AUTO-OPTIONS SHOP

DRAINAGE PLAN

TRACT 1-A-2, HAGER INDUSTRIAL PARK #2
ALBUQUERQUE, NEW MEXICO

LOGAN/GROSS & ASSOCIATES, INC. CONSULTING CIVIL ENGINEERS 501 KINLEY N.E. 243-6353 ALBUQUERQUE, NEW MEXICO 87102	
DRAINAGE PLAN	File # H-36
FOR: J A CAMPBELL CONSTRUCTION	Date 3/20/86
AT: 8506 TRUMBULL AVE SE	Drawn CLB
ALBUQUERQUE, N M	Sheet 1 of 1

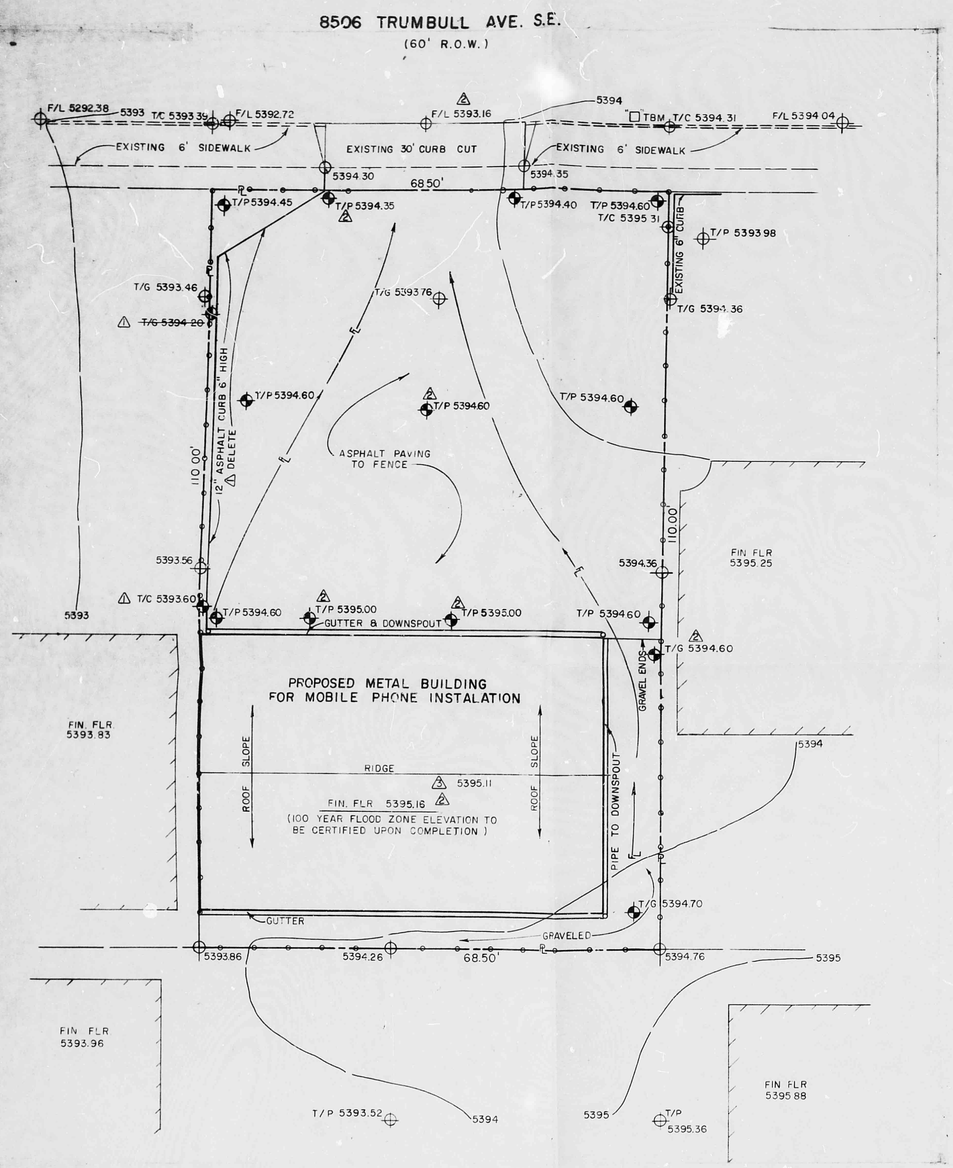
REVISION: △2 6" HIGH CURB ON WEST PROPERTY LINE TO BE DELETED. SURFACE FLOW ACROSS TRACT 1-A-1 TO THE WEST IS COVERED UNDER "GRANT OF DRAINAGE EASEMENT" FILED MAY 2, IN THE OFFICE OF THE COUNTY CLERK OF BERNALILLO COUNTY, N.M. IN BOOK MISC. 347A, PAGE 968.
